COUNCIL PANEL ASSESSMENT REPORT

Panel Reference	2017SNH084
DA Number	DA0610/17
LGA	Ku-ring-gai
Proposed Development	Demolition of existing structures and construction of a mixed use development comprised of shop top housing containing 56 apartments, use of ground floor commercial space as an Aldi supermarket and small retail suite, basement parking, signage and associated works
Street Address	810-818 Pacific Highway, Gordon
Applicant/Owner	RPS Group / Pacific Highway Gordon P/L & Ku-ring-gai Council
Date of DA Lodgement	11 December 2017
Number of Submissions	7 submissions in response to 1 st notification, 1 submission in response to notification of amended plans
Recommendation	Refusal
Regional Development Criteria (Schedule 7 of the SEPP (State and Regional Development) 2011)	CIV in excess of \$20 million Works on land to which Council has an interest in excess of \$5 million
List of all relevant s4.15(1)(a) matters	<ul style="list-style-type: none"> • SEPP 55 – Remediation of Land • State Environmental Planning Policy No. 64 • State Environmental Planning Policy No. 65 • SEPP (Infrastructure) 2007 • State Environmental Planning Policy (BASIX) • Sydney Regional Environmental Plan

Figure 3: Excerpt DA05 (E) Ground Level - unresolved impacts to streetscape for public / private domain interface as identified

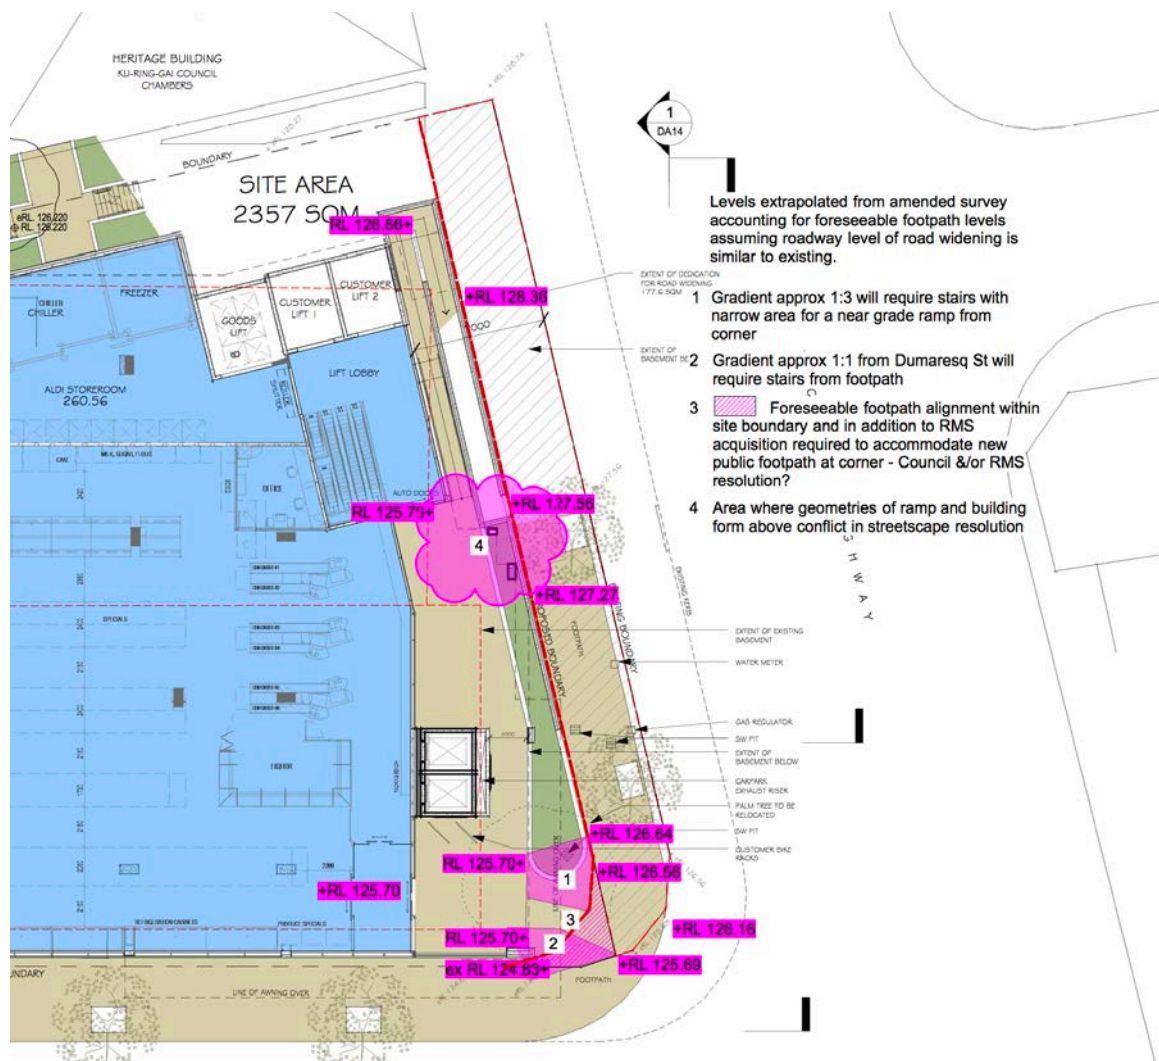
- a) *Supermarket floor level relationship to future footpath levels – no amendments to resolve the difficult relationship of the internal floor level with the sloping adjacent footpath levels and physical activation of the ground floor commercial/retail frontage addressing the Highway despite some additional window area achieved via the excavated ramp. This fails to satisfy Ku-ring-gai's specific planning controls for ground floor commercial uses KDCP_LC 8C.10 objectives 1, 2, 3, 4 and controls (1), (2), (3), (4), (7) which all directly relate to the importance of the relationship between internal floor levels and adjacent footpaths to achieve the intended urban character, accessible pedestrian activity, enhancing pedestrian amenity and providing direct physical and visual connection between the private and public domain.*

- b) *ALDI access ramp – creates an unpleasant interface relationship affecting approximately 40% of the primary street frontage. Despite the partially increased window area that is achieved, the extent of the ramp impact is exacerbated due to the height differential between the footpath and proposed supermarket floor level.*

Figure 4: Excerpt DA06 (E) Level 1 - unresolved impacts to streetscape and access as identified

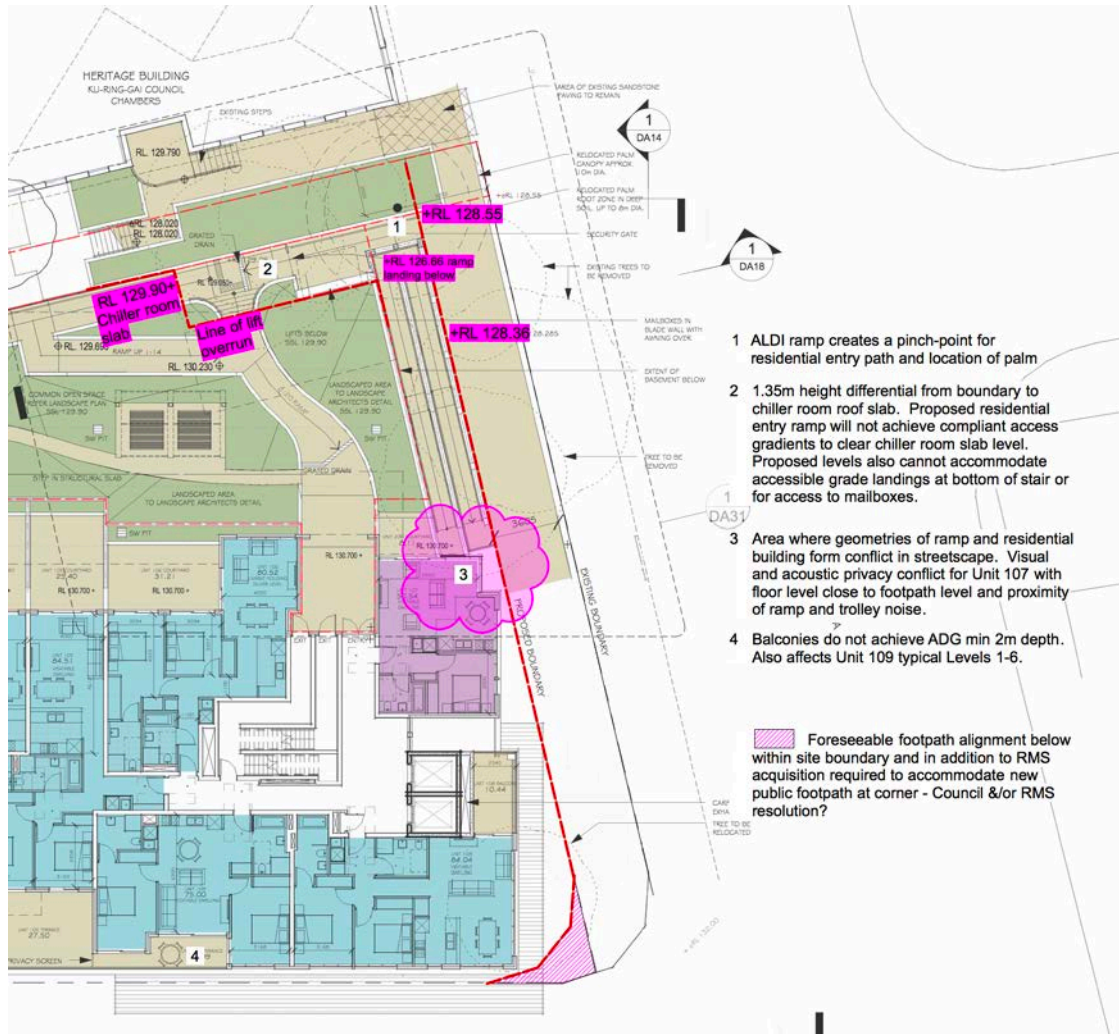
c) Relationship between the geometries of the ALDI pedestrian ramp and building mass of Unit 107 and above - is awkward. Resolution of the pedestrian ramp results in an awkward conflict at the junction of the ramp and building mass above that will be just above pedestrian eye-height. It will be prominent in the streetscape being at the most visible north-eastern corner and located on the new boundary line. This is largely a result of proposed floor levels of the ground floor supermarket and first floor residential above necessitating an excessively long ramp and resulting in a poor relationship of residential use to the ground plane in a B2 zone.

d) Extent of street activation remains largely below boundary ground levels along the Highway frontage – the effect is now exacerbated by the land acquisition because 4m of the site that had been available to resolve the disparate ground levels is no longer available. The supermarket floor level remains set too low across the sloping topography to achieve the desired character of an activated street frontage on this visually prominent site viewed from the public domain on all boundaries. Photomontage view DA28 (B) clearly demonstrates the lack of visual street activation. It appears as a

Figure 6: Calculation sheet for GFA showing much of the loading level is not included in the calculation of GFA but adds to the height and bulk of the building

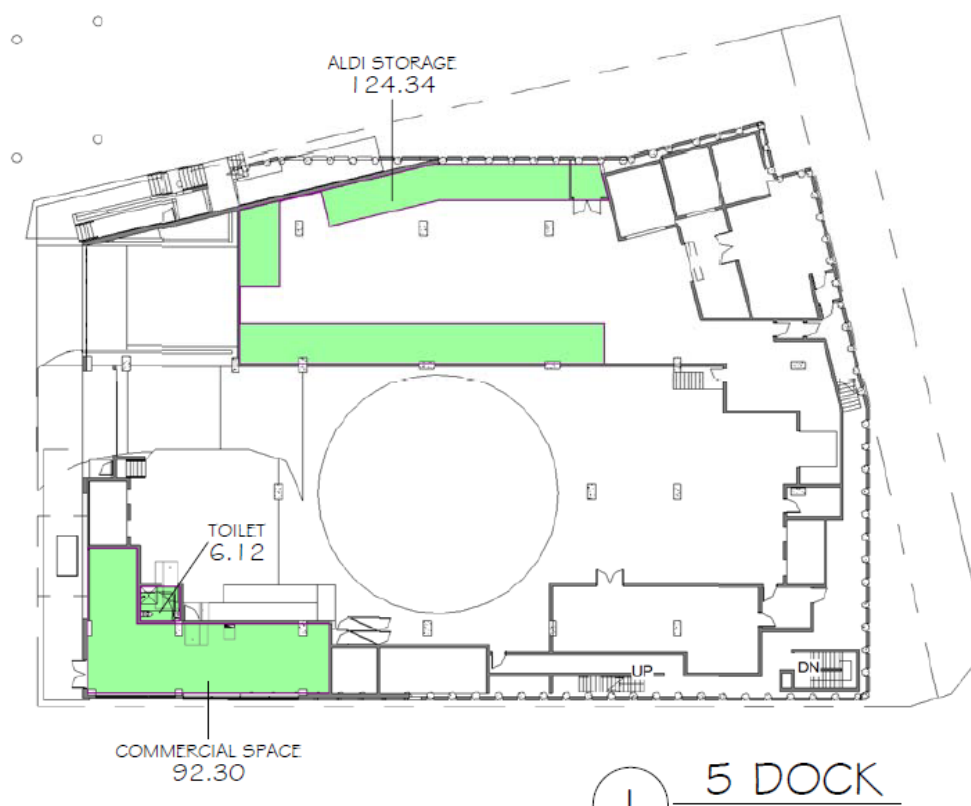
The second key element is that the application is for a supermarket. A supermarket, usually but not always, has a single large level floor plate which is difficult to achieve on a steeply sloping site and results in the design approach seen in the subject application of a supermarket which has a floor below the footpath level in Pacific Highway by up to 2.5m, above the footpath level in Dumaresq Street by up to 6.5m and above the footpath level in Radford Place by up to 7.2m. The use for a supermarket also requires significantly larger loading and goods handling areas than other uses in a mixed use development, which needs to be provided with significant floor to ceiling height to allow large trucks to enter the site. As can be seen in the following figure (figure 6) which shows the areas of the loading level of the development which are included in the definition of GFA, the significant majority of this level is excluded from the FSR calculation. As such, whilst the applicant is correct in stating the proposal is compliant with the FSR, simple compliance does not tell the full story in relation to the height and bulk of the proposed development. As can be seen from the rear elevation, the first 7m of height of the building is largely not included in FSR calculation, but it does significantly add to the height of the development.

The third key element is the applicant's choice to provide a lesser setback to Pacific Highway than that required in the DCP and a significantly greater one than required in the DCP from the northern boundary. This design choice, apart from making it more difficult to provide appropriate accessibility into the supermarket, narrows the building, which in order to achieve the maximum FSR, pushes the development higher.
